AMENDMENT OF SOLICITATION/MODIFICATION OF CONTRACT

1) Provide Questions and Answers - refer page 2 of SF-30-A0001
2) Provide Revised Scope of Work - refer pages 3 to 18 of SF-30-A0001
3) Provide drawings - refer pages 19 to 29 of SF-30-A0001.

Question & Answer Solicitation No.191N6526Q0066 Title: Waterproofing of GSO Office Spaces Date: 18 June 2026
Note: Contractors are advised to submit cut sheets of all the products which they are cosidering in their bid for evaluation.

Roof Replacement of Office Spaces Roofs

Drawing Title
TYPICAL WATER PROOFING DETAIL

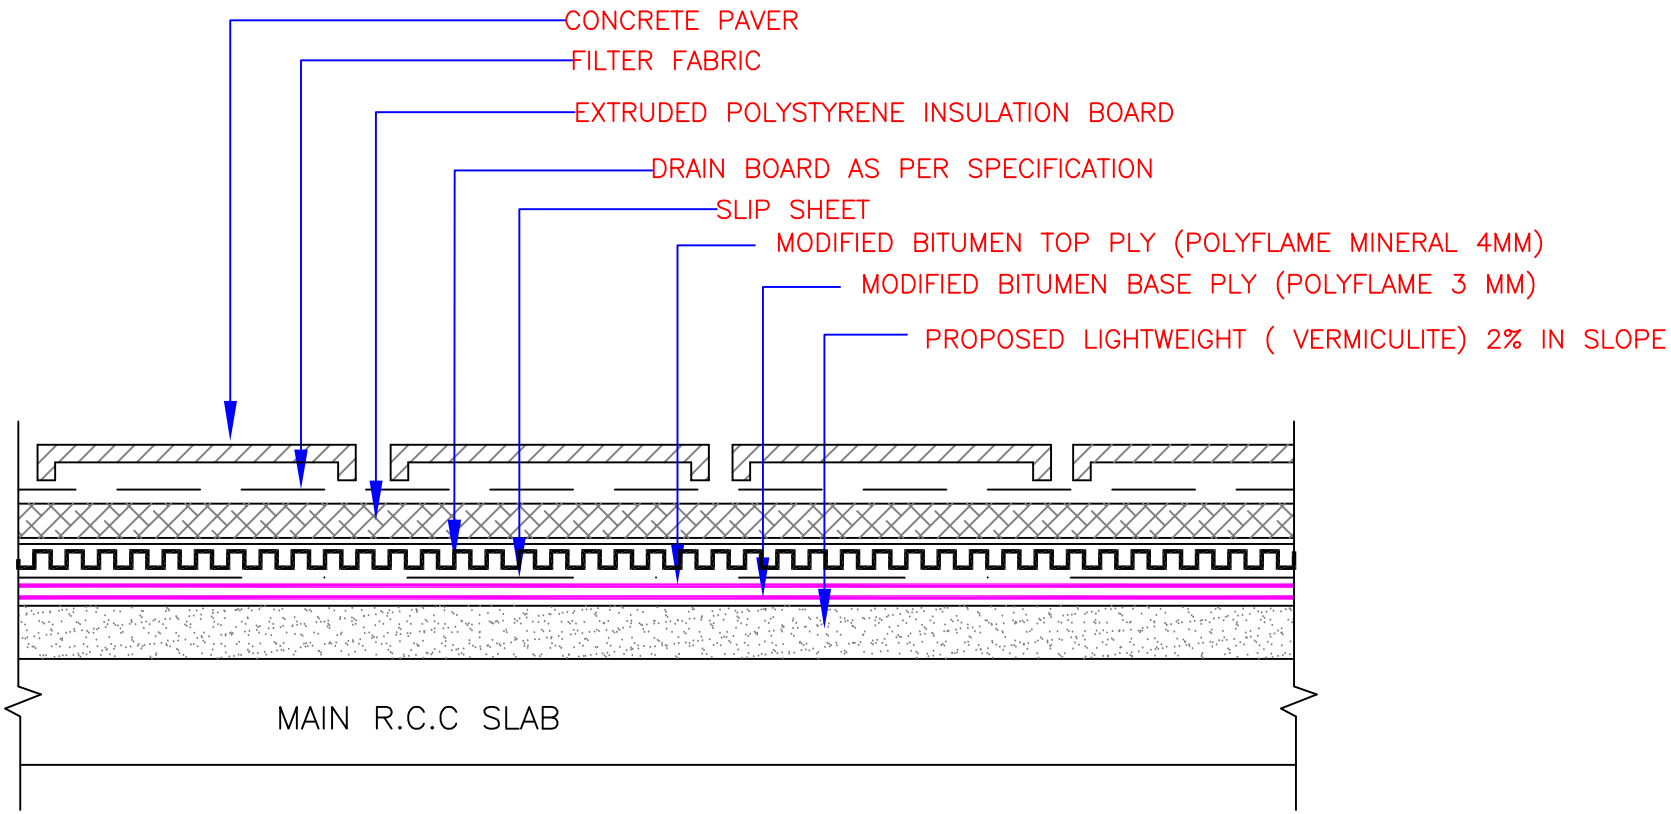
Question-1: Kindly provide drawing of slab with measurement and with position of drain marked, cross section of existing waterproofing layer with thickness and proposed waterproofing layers,Detailed drawing of flashing

Answer-1: Refer attached drawing for measurements, location of drains, flashing, details of terminations and proposed waterproofing layers. Average thickness of existing layer is 5-6” with layers comprising of – a. two membrane on the top. b. terrazzo tiles layer. c. PCC. d. Insulation board. e. Membrane and primer on mother slab.

Drawing Title
TYPICAL WATER PROOFING DETAIL FOR EXPANSION JOINTS ON ROOF

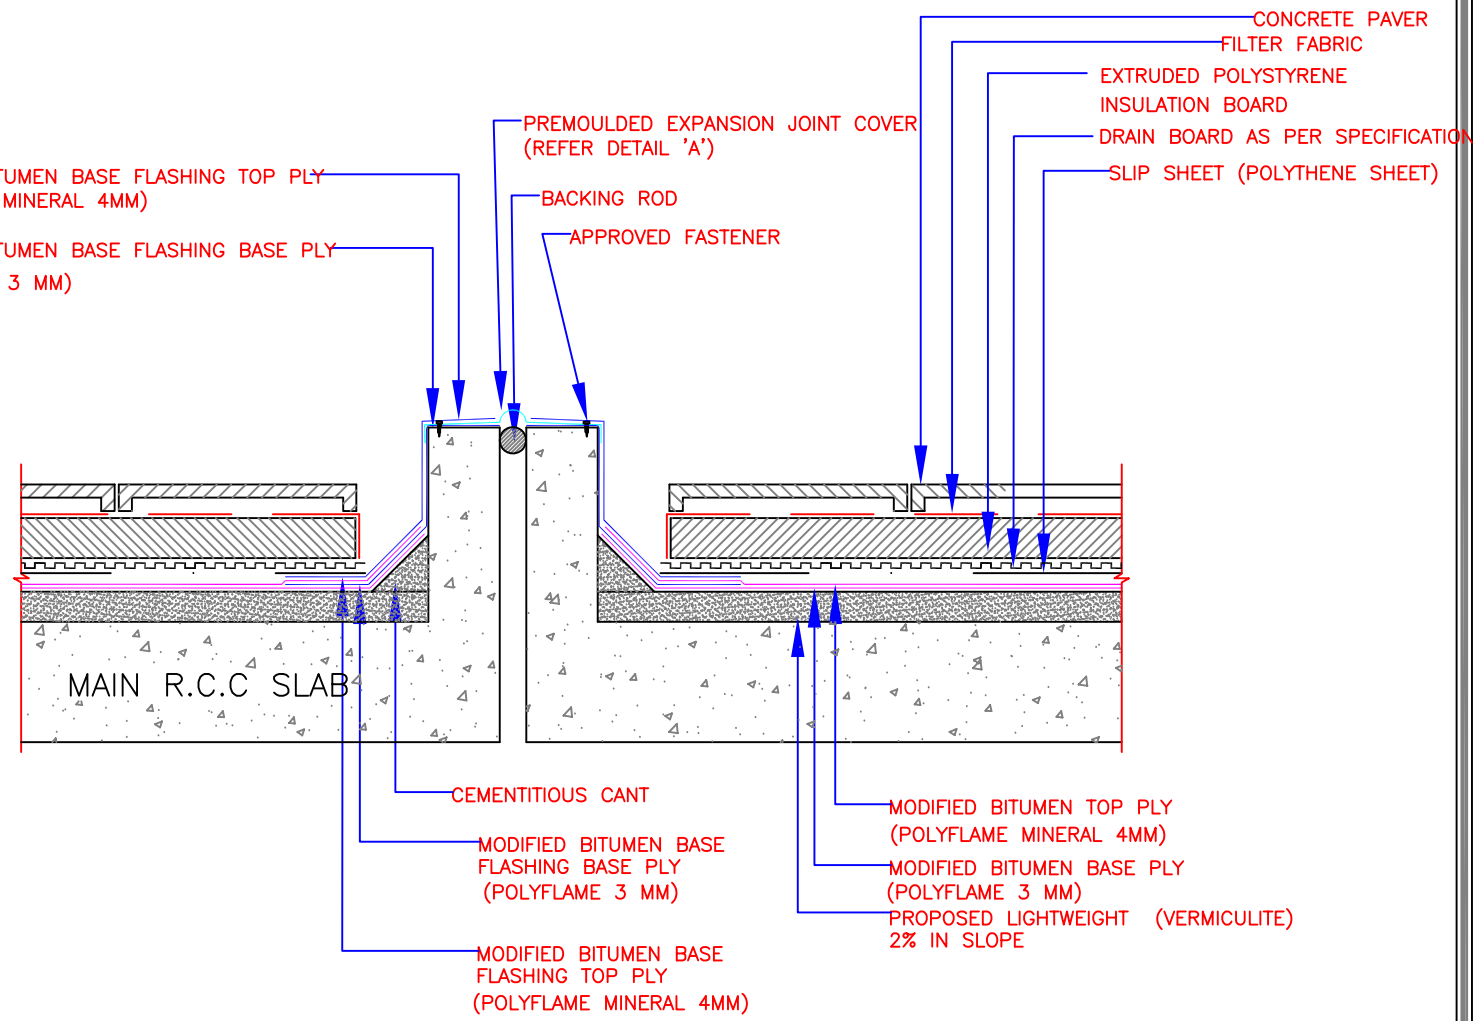
Question-2: Kindly let us know whether PCC of employees are required
Answer-2: PCC is not required
Question-3: Do we need to put flashing on expansion joint as well and do we need to repair expansion joint from both the sides?

Answer-3: Yes, expansion joint needs to be treated as shown in drawing package.
Question-4: Do we have to submit performance or guarantee bond for the work if assigned?
